SSD-9670 - WSU Innovation Hub

2-6 Hassall Street, Parramatta
Section 4.55(1A) Modification Report

Submitted to Department of Planning, Industry
and Environment

Figure 1 Suggested wind treatments, Ground Level Plan

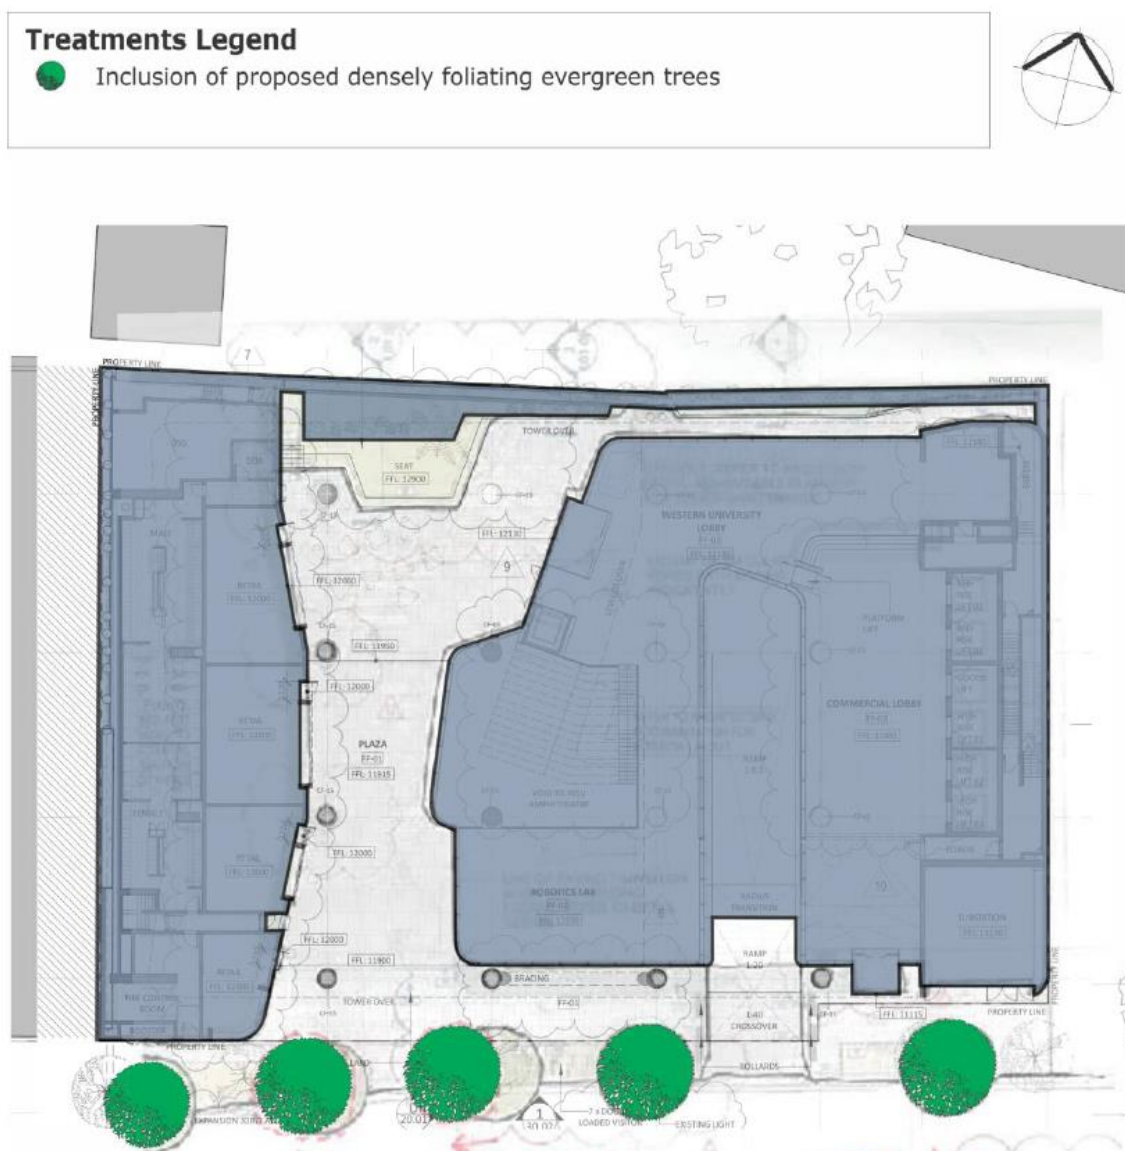
- Inclusion of the proposed trees at the southern entrance to the through site link, as referenced in Figure 7 of the wind report (and reproduced below). These trees should be densely foliating.

In relation to the recommendation above, the approved landscaping plan includes proposed street tree planting in locations generally consistent with the recommended locations. The final locations of the above trees will be coordinated with Council's Public Domain Section and resolved prior to commencement of public domain works.
